Stage 1 GHG Calculator Changes February 29, 2008

This document compiles comments made by parties and agency staff on the Stage 1 Greenhouse Gas (GHG) Calculator and the CPUC's "Administrative Law Judges' Ruling Requesting Comments on Modeling-Related Issues" (CFT/JOL/k47 11/9/2007)¹.

Figure 1. Old and New Wind Integration Costs in \$/MWh of Wind Energy Generated, as a Function of Wind Penetration

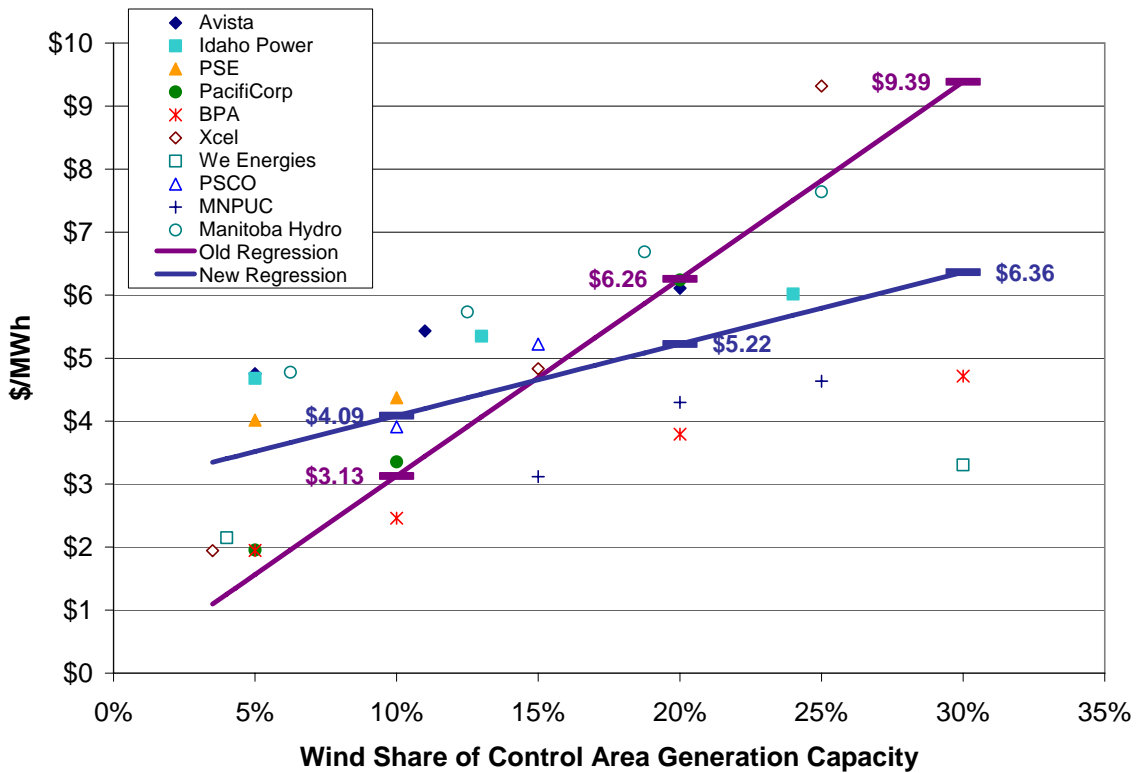
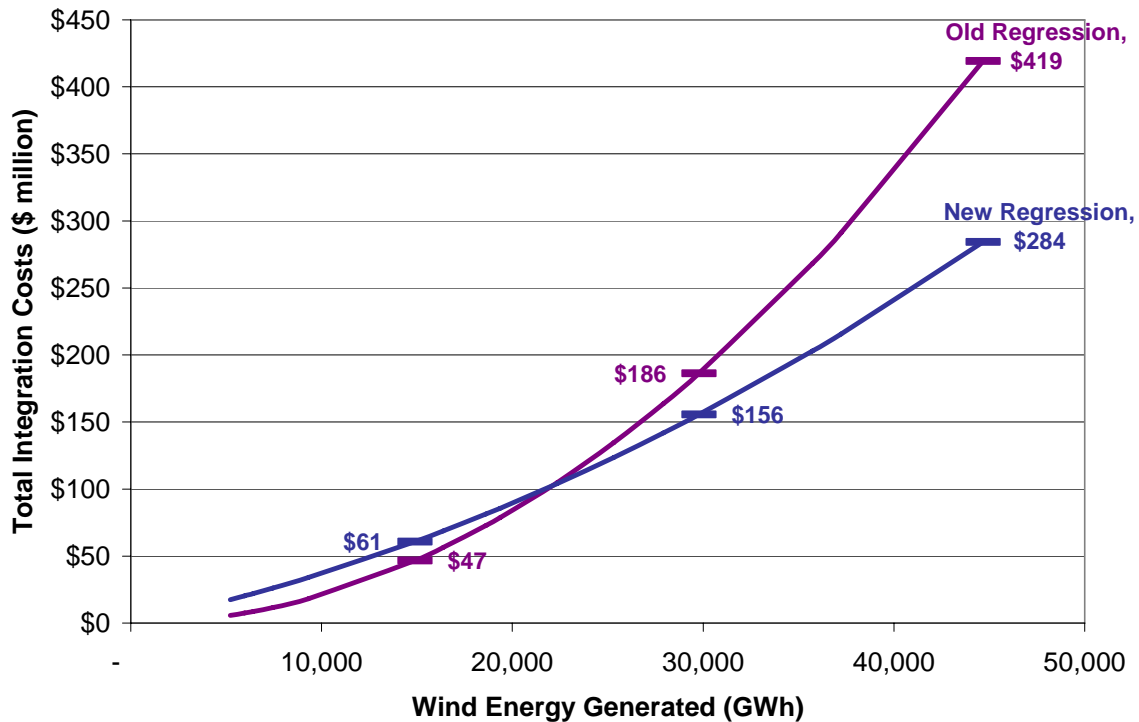
Comments: Stakeholders submitted varying views regarding the wind integration costs assumed in the reference cases of the GHG calculator. While WPTF argued that the estimates are too low, (p. 4), SCE argued that the costs are about right but that the methodology for calculating costs should be altered, (p. 26-27), and NRDC/UCS (p. 10-11) and CEERT (p. 37) argued that the costs are too high. In general, the GHG calculator allows users to change costs in order to create a user-defined scenario. However, E3 agrees that the calculator should be set-up to more easily allow users to change the wind integration cost assumptions.

Comments: This change is being made in response to comments suggesting changes to the wind intermittency costs made by SMUD, (p. 8), NRDC/UCS (p. 10-11), CEERT, (p. 32-34).

Proposed Change: E3 will recalculate the wind integration cost function, replacing the Idaho Power and Avista study numbers used previously, with the stipulated values that the Idaho PUC approved in its settlement stipulations for Idaho Power and Avista on February 20, 2008. In addition, E3 also accepts NRDC's criticism that the slope of E3's regression analysis is steeper than the slopes of most individual studies, resulting in integration costs that are typically lower than the individual study results for lower levels

of wind penetration and higher than the individual study results at higher levels of wind penetration. In recognition of the fact that the GHG analysis is more interested in accurate estimates of costs for high levels of wind penetration than for low levels of wind penetration, E3 has changed regression analysis technique (including a y-intercept in the regression). This results in a reduction of the average slope from 0.3 to approximately 0.1. Figures 1 and 2 below show the results of the new analysis.
